THE RESERVE AT CORRAL BLUFFS SUBDIVISION

FILING NO. 3 Construction Drawings El Paso County, Colorado

PCD File No. SF20-7

GRADING AND EROSION CONTROL PLAN

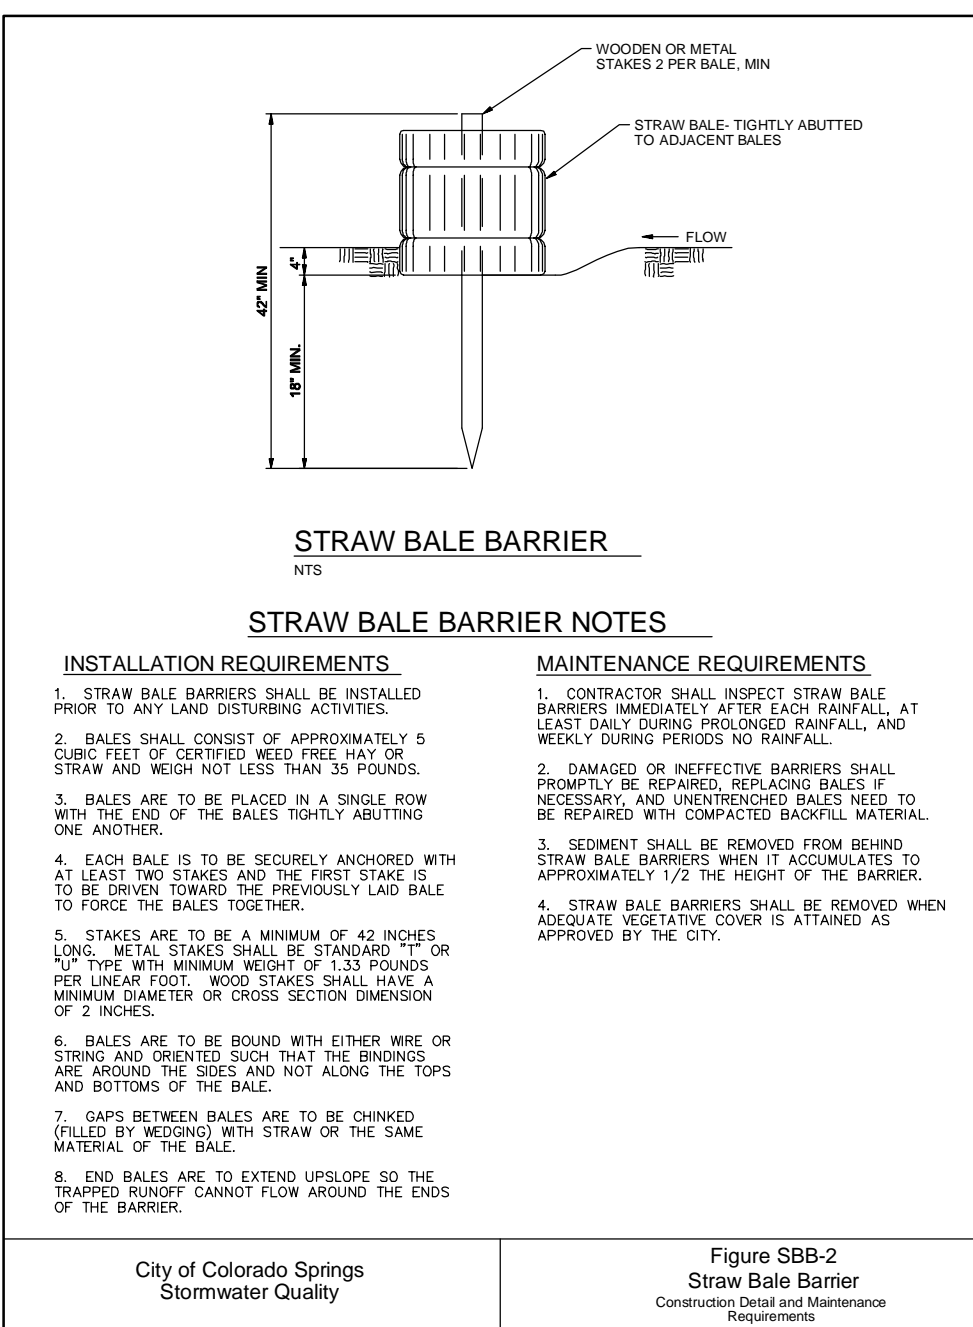
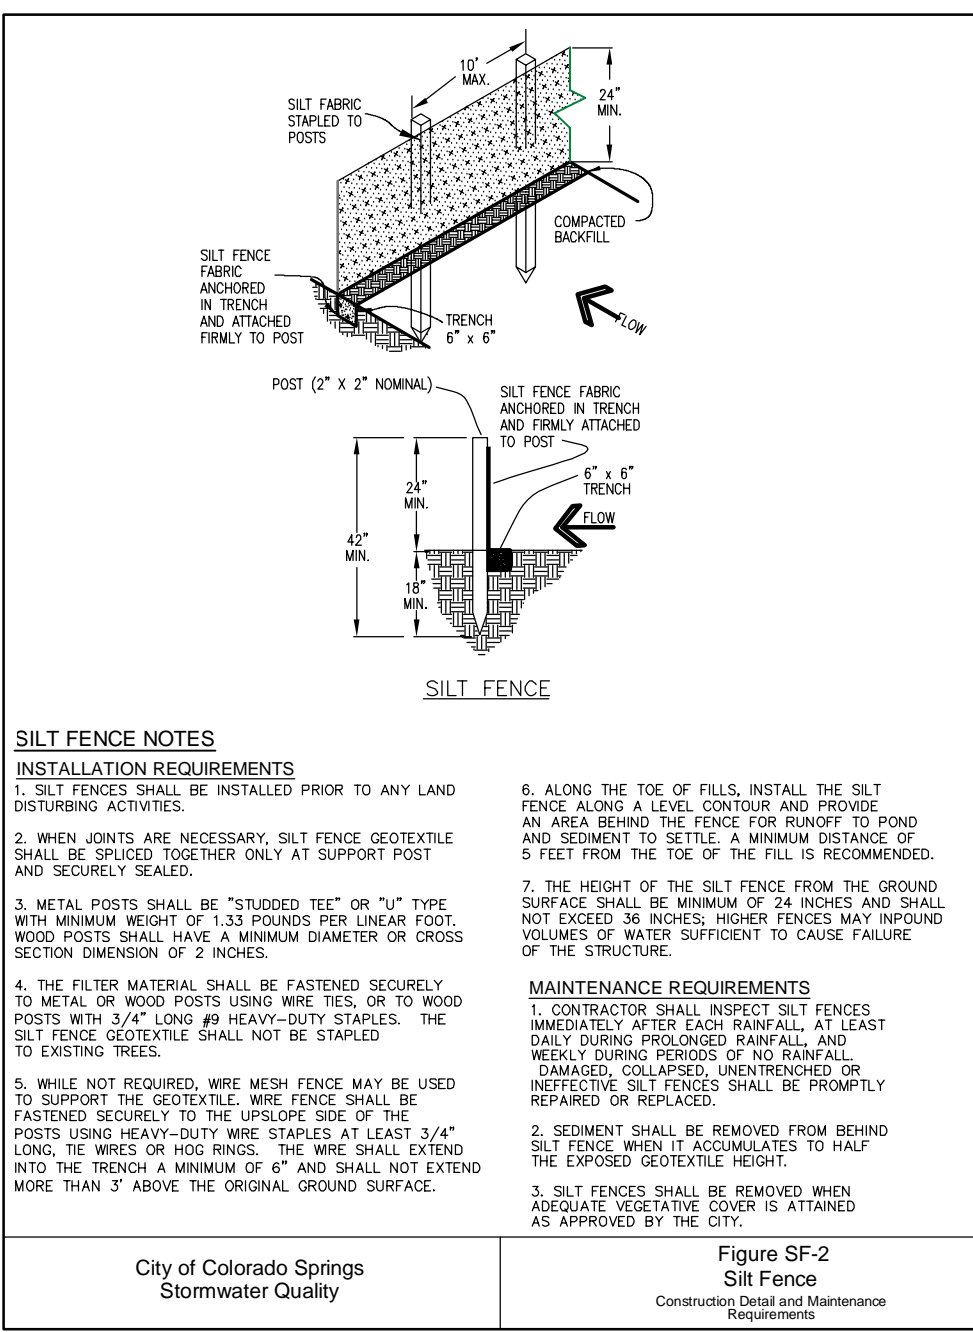
Disturbance is over 1 acre. Need temporary sediment basin to treat stormwater. Unresolved.

You will need a temporary sediment basin at the start of construction -- prior to the installation of the rain gardens.

Add temporary sediment basin to BMP Phasing
 Unresolved.
 Add rain garden construction to BMP Phasing

Add a note about the existing vegetation
 Add a note that no dedicated asphalt or concrete batch plants are planned on-site.
 Add a note stating that contractor shall update and annotate the SWMP Maps to show the location of the construction trailer, stabilized staging area, CWA, and other items as these locations are determined on site.
 Unresolved.

EROSION CONTROL NOTES & DETAILS

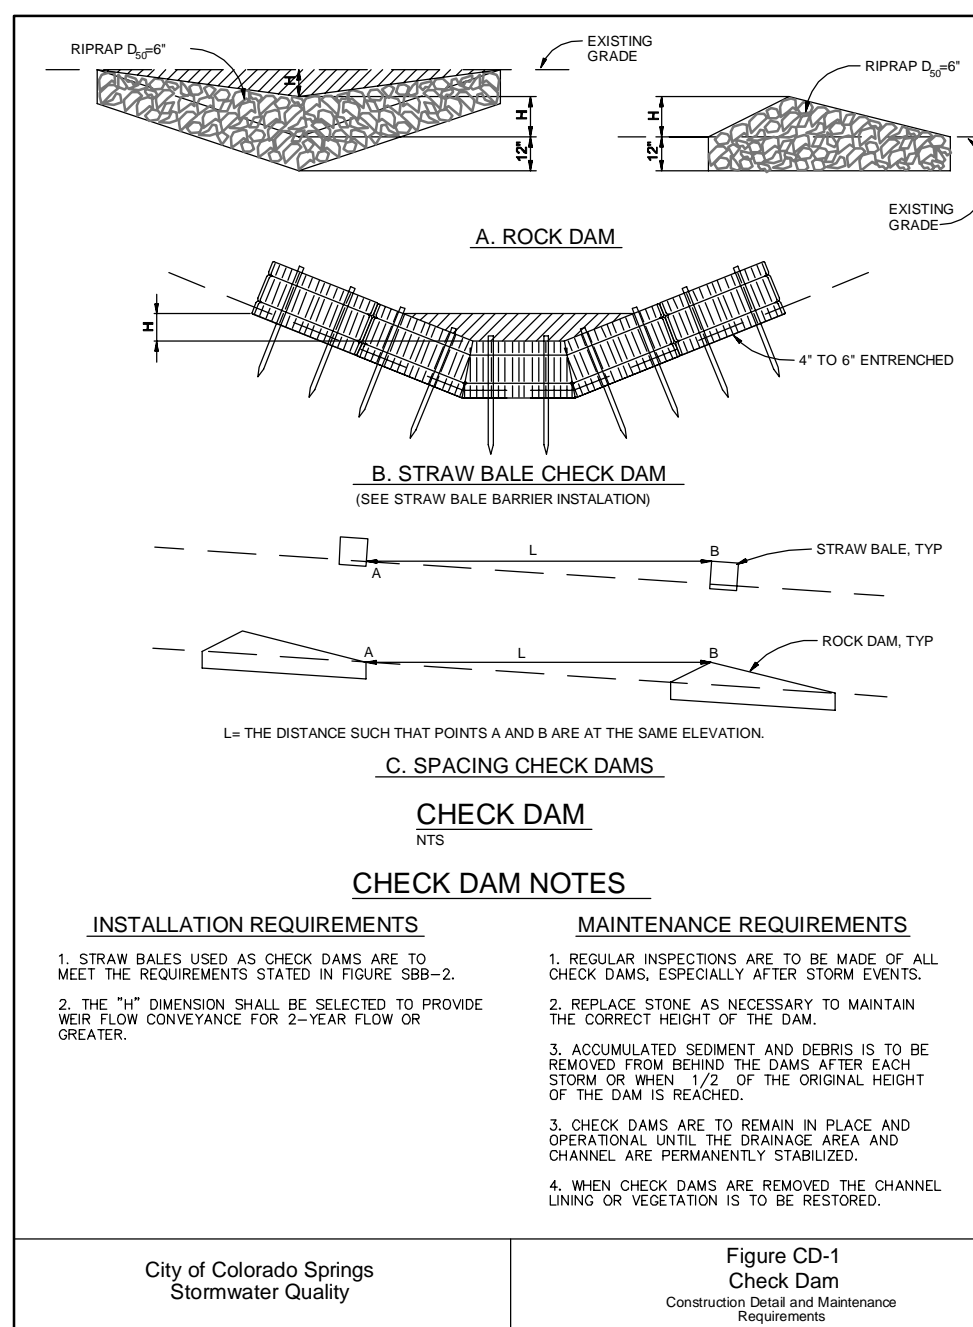
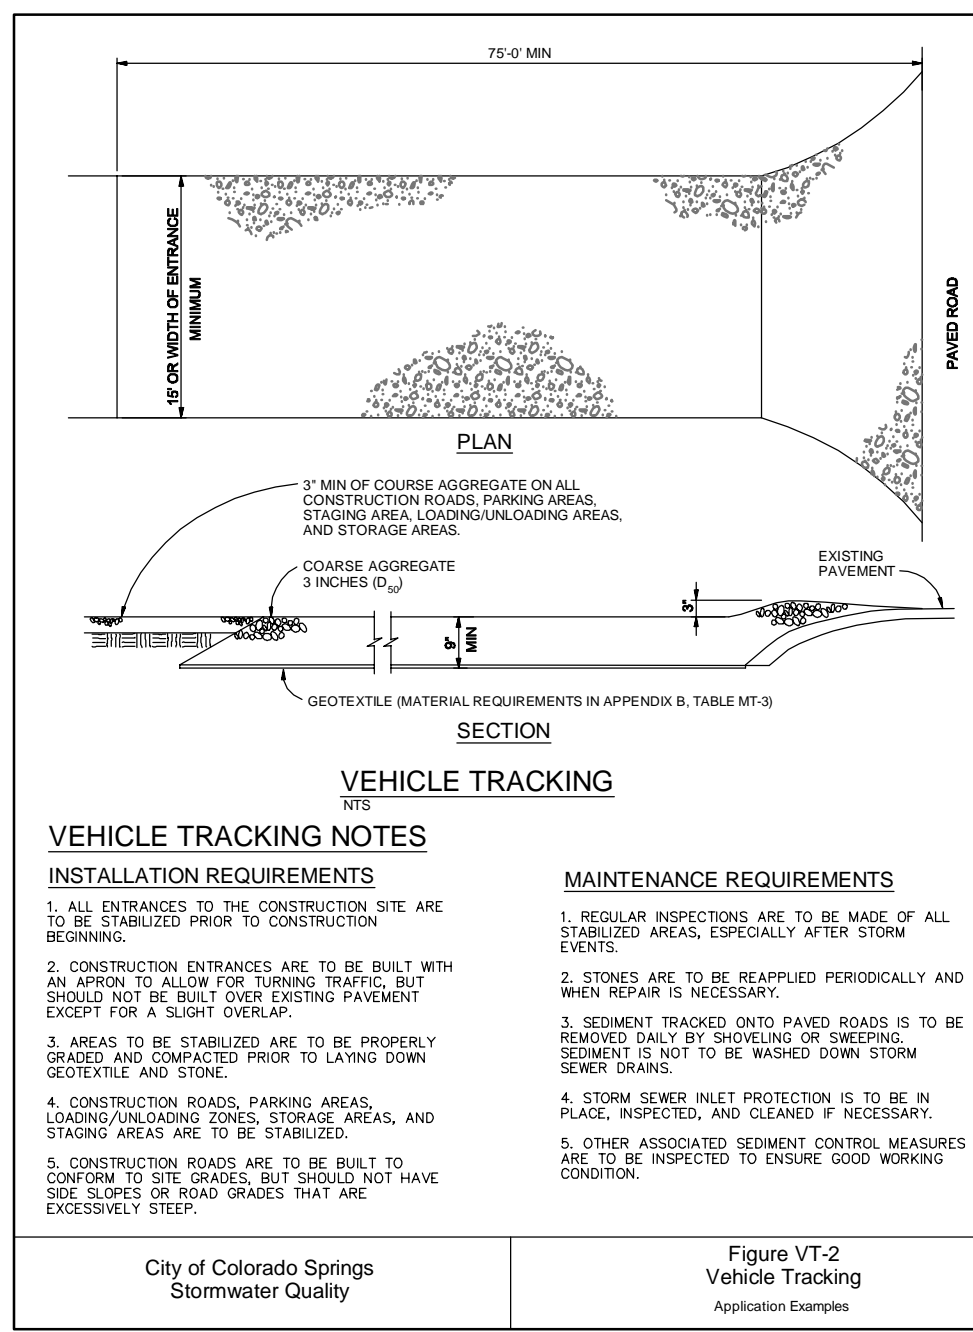
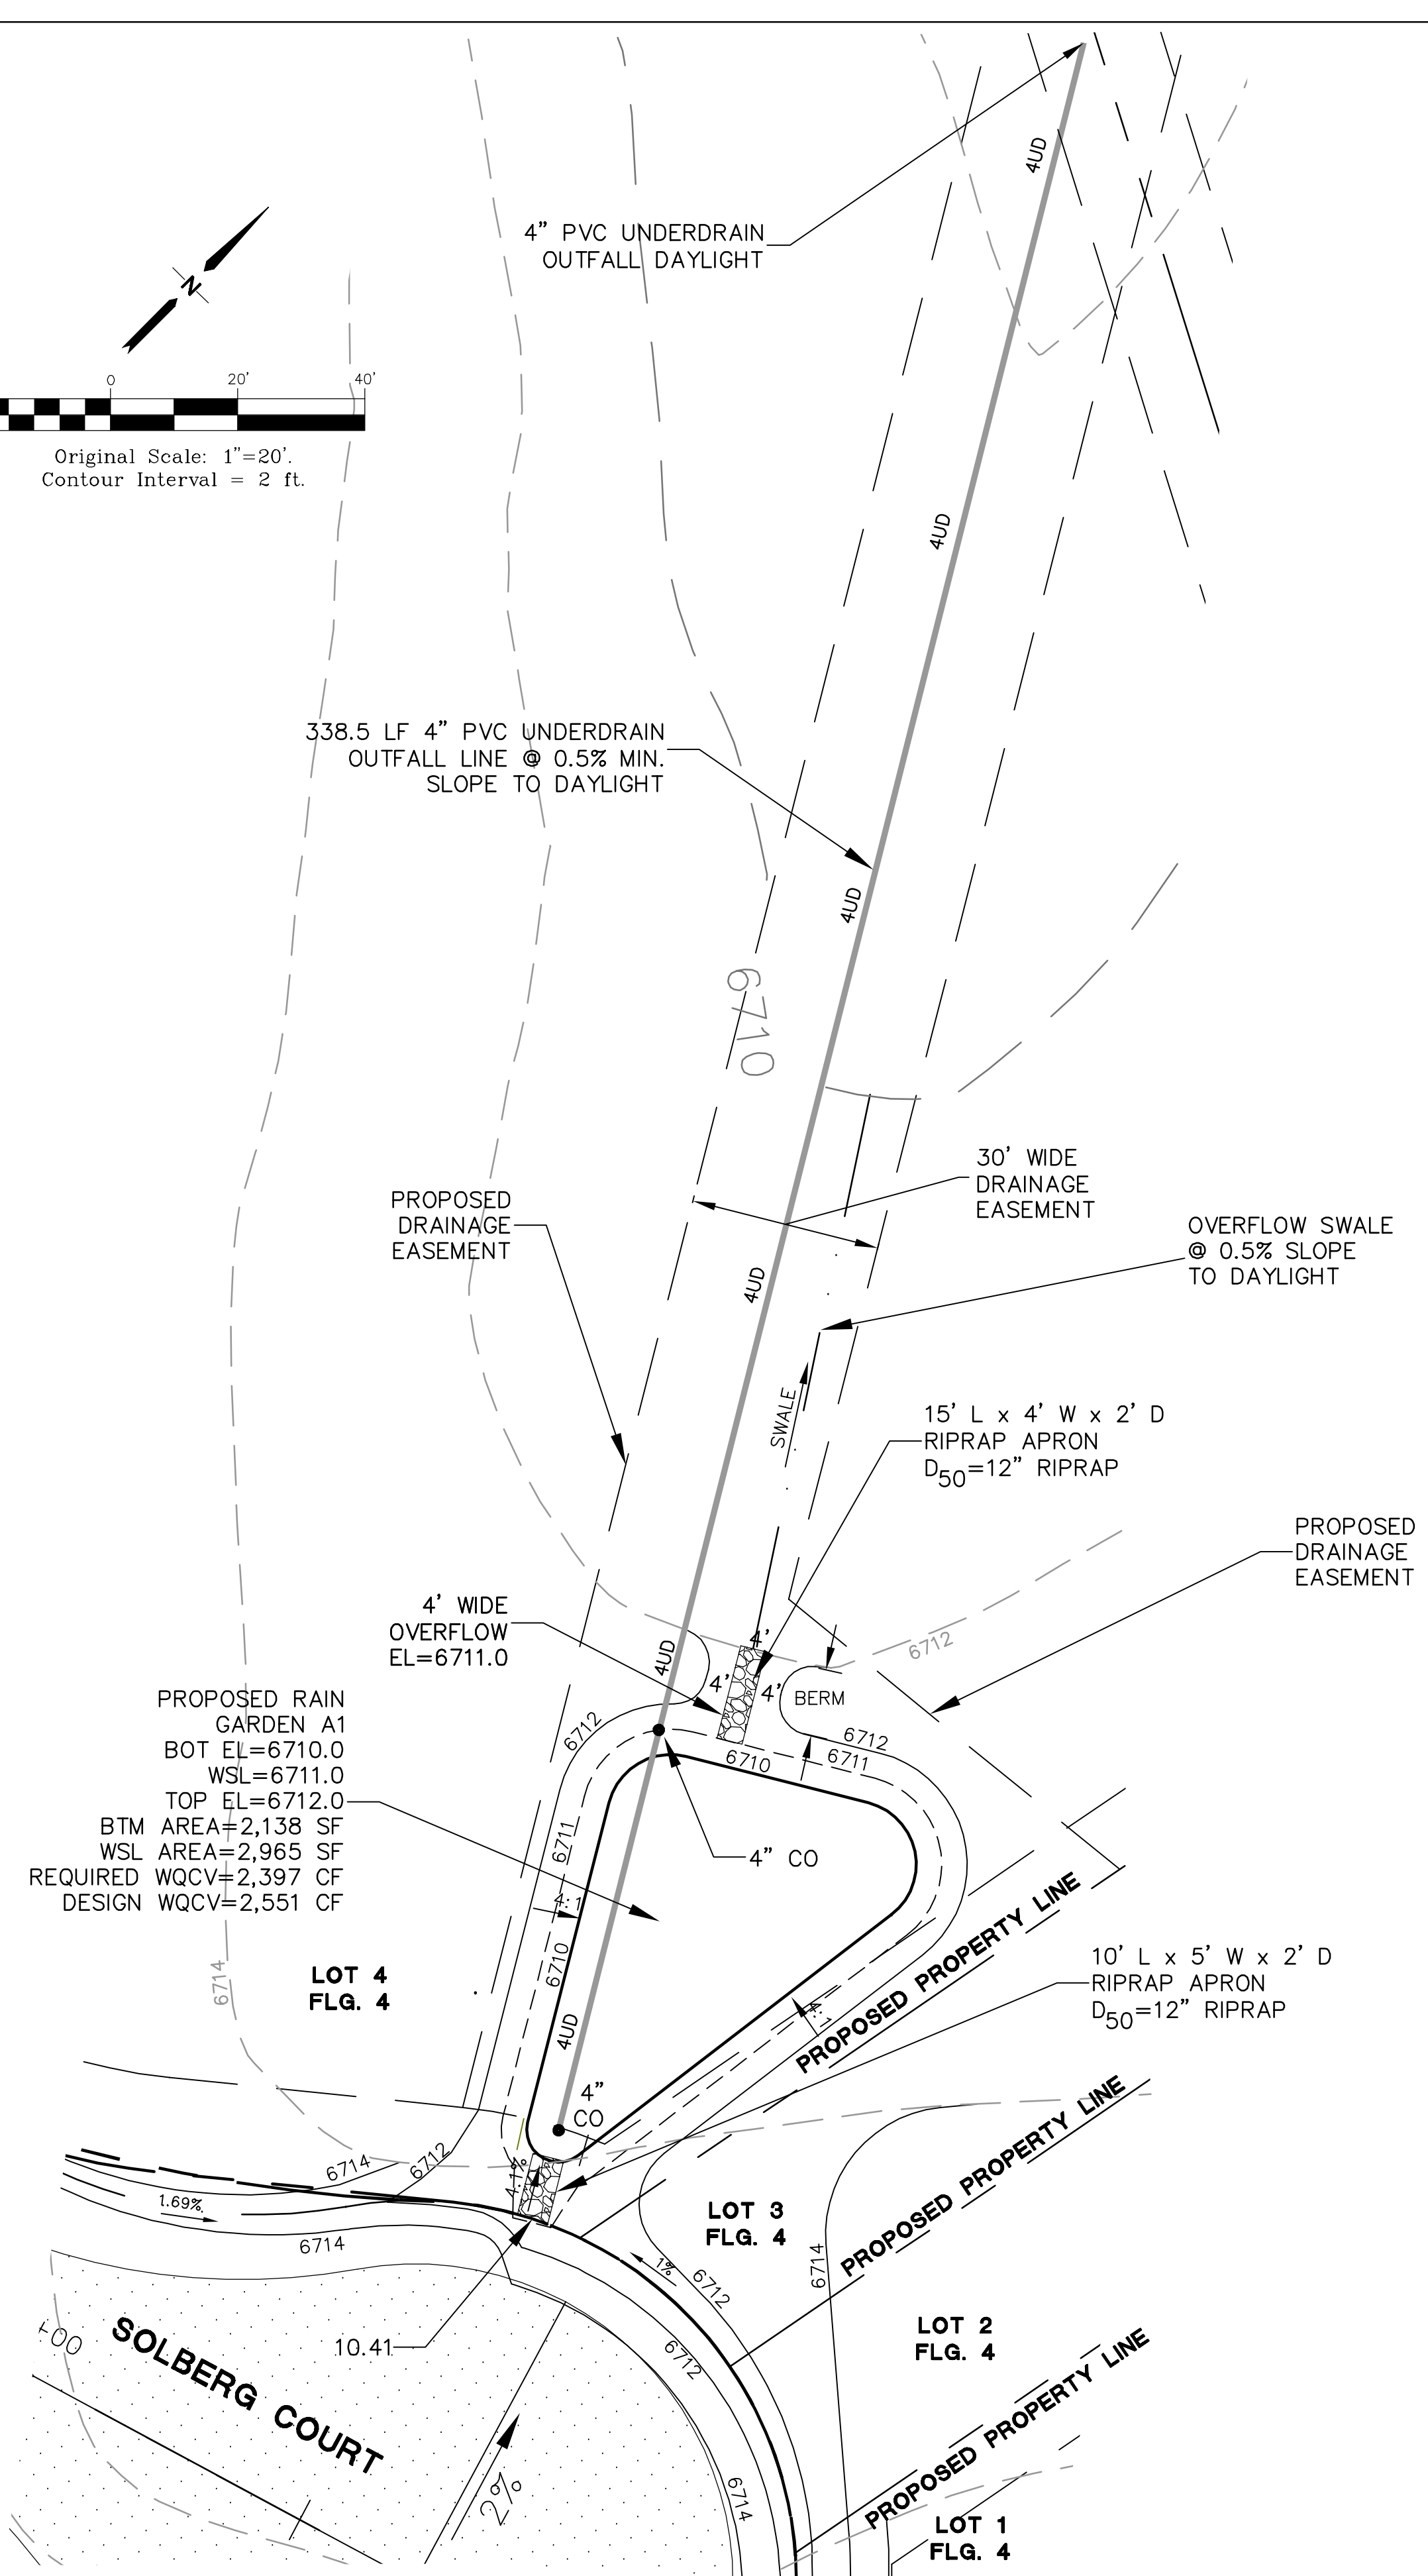
Provide erosion control blankets
 Provide erosion control blankets
 Unresolved.

provide the date and preparer of the soils report
 Unresolved.
